## Riley Purgatory Bluff Creek Watershed District Permit Application Review

**Permit No:** 2023-077

**Project:** Enclave at Manor Road Residential Development – The applicant proposes the demolition of an existing single-family home and the construction of a 17-lot single-family residential development.

**Reviewer:** Scott Sobiech, PE, Barr Engineering

Figure 3

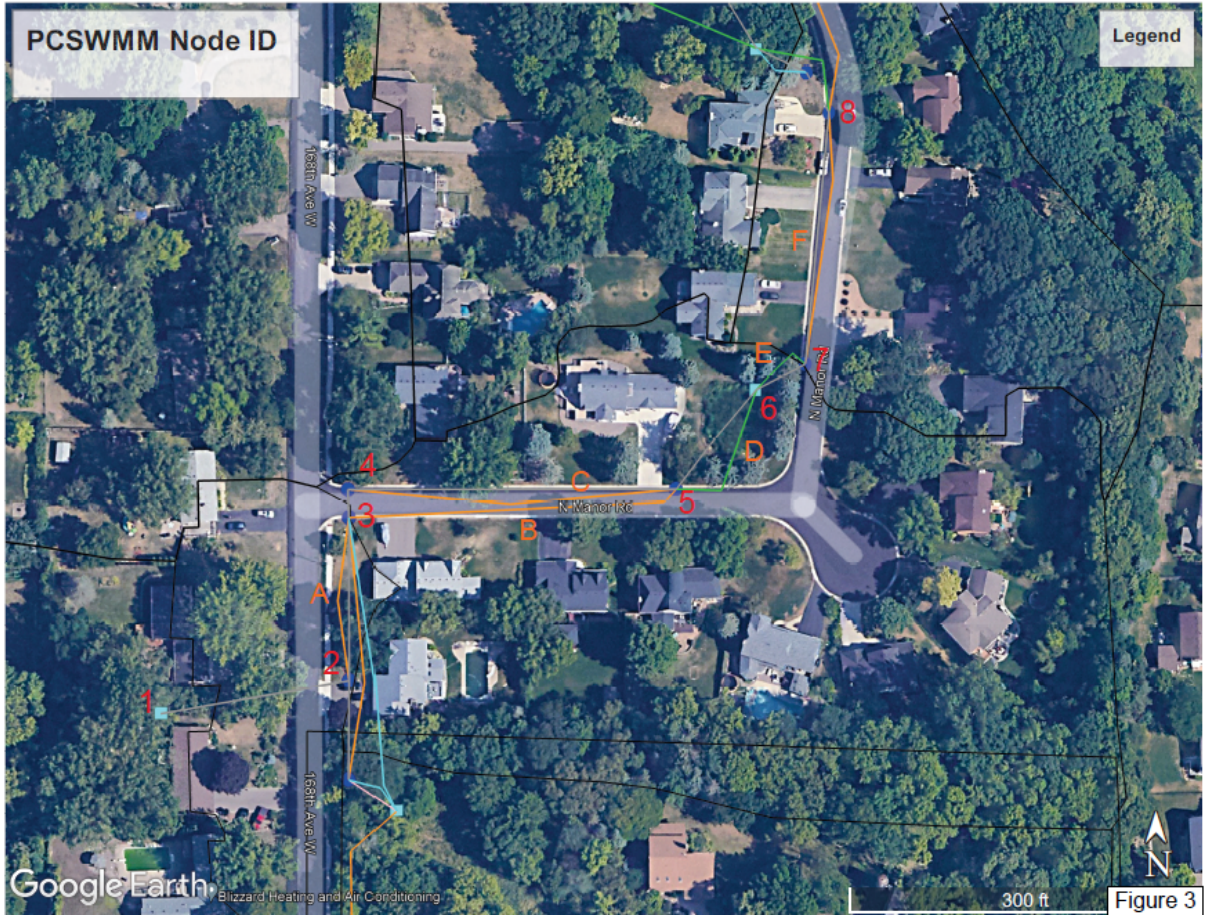
- Regarding variance criteria 2 and 3 –The additional flow into the existing 18-inch storm sewer would exacerbate a known flooding problem to the west of 168<sup>th</sup> Avenue. The applicant is proposing to increase the diameter of existing storm sewer along 168<sup>th</sup> Avenue from and 18 inches to 21 inches to accommodate the additional flow. The following information provided by the applicant summarizes the off-site flood risk impacts at several locations shown in the below image. The proposed storm sewer replacement and discharge routing provides a reduction in the 100-year flood elevation at several locations (-0.03 to -0.29 feet) and some increases (0.06 to 0.18 feet) at other locations. The applicant provided information demonstrating that the locations with an increase in the 100-year flood elevation are within the road right of way or city drainage and utility easements. While the flood elevations at locations 6 and 7 would increase by 0.1 feet and 0.2 feet respectively, the lowest adjacent ground to the structures is about 2 feet higher than the proposed 100-year high water level. The lowest floor elevation adjacent to location 6 is 913.27 feet which is 0.63 feet below the pond's existing 100-year flood elevation. Under proposed conditions the flood elevation at this location would increase by 0.1 feet.

Figure 3

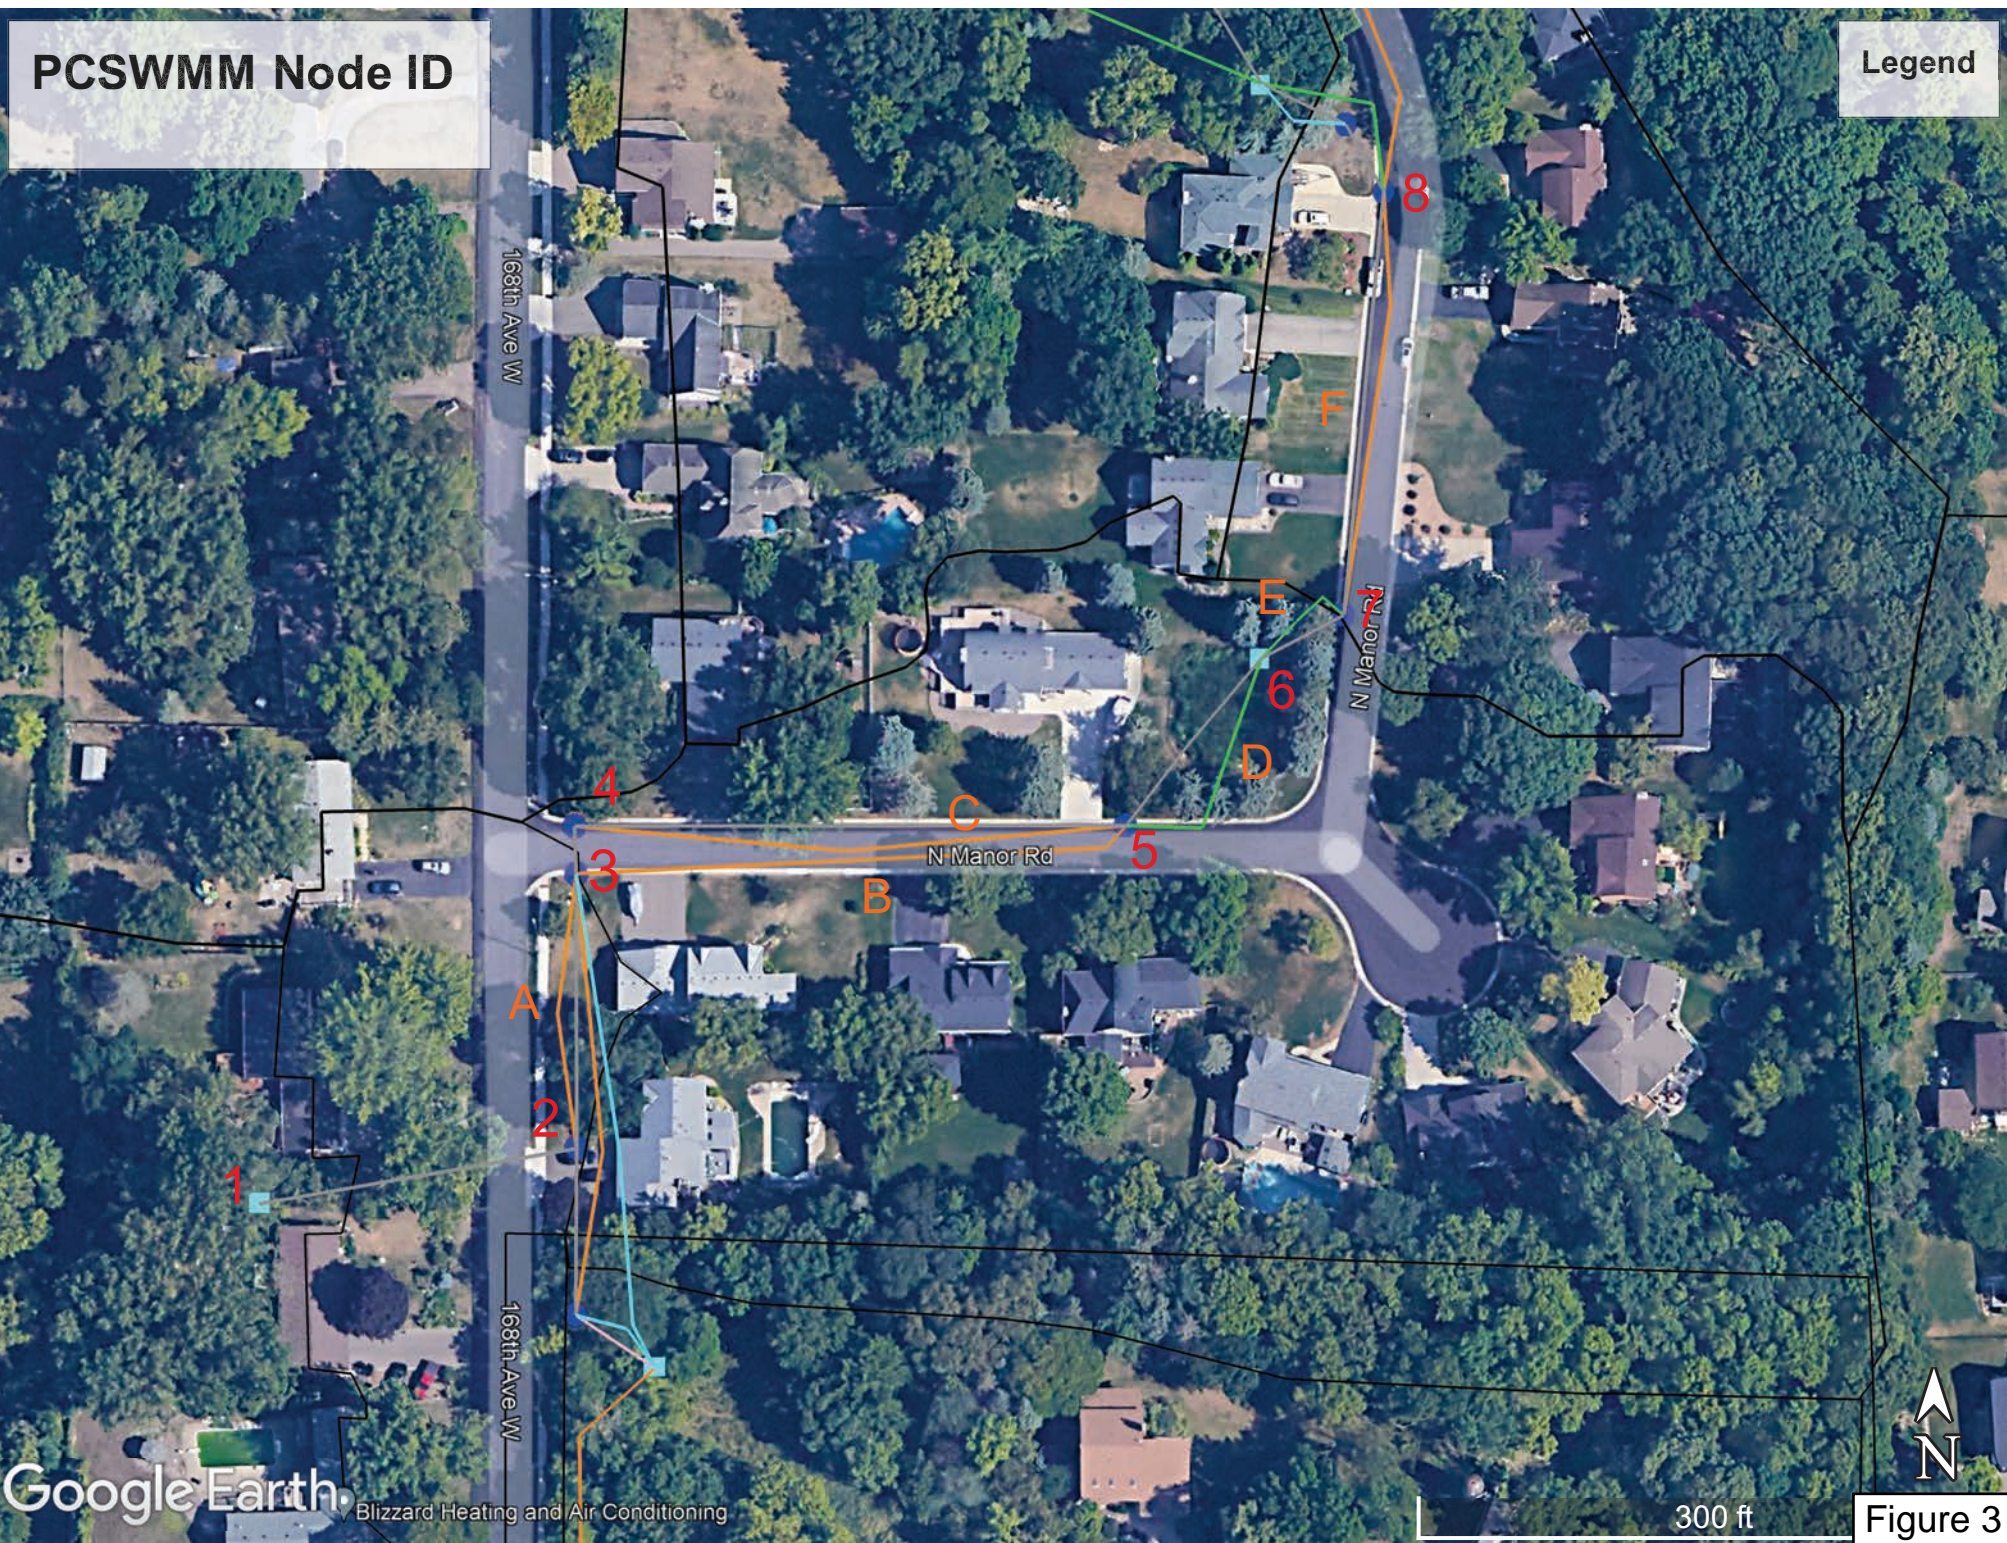
**1.2 The effect of the variance on government services** - The proposed condition will lower the 100-year high water level (HWL) of the low area northwest of Honeysuckle Lane and 168<sup>th</sup> Avenue. This is achieved by improving the capacity of the pipe running parallel to 168<sup>th</sup> Avenue. However, the increased flow through this pipe affects HWLs downstream, which are presented in **Table 1**. Minor increases in street flooding occur, however, the depth of inundation will not impede emergency traffic. See **Table 2** for more information. **Figure 3** denotes the locations of the modeled nodes referenced in Tables 1 & 2.
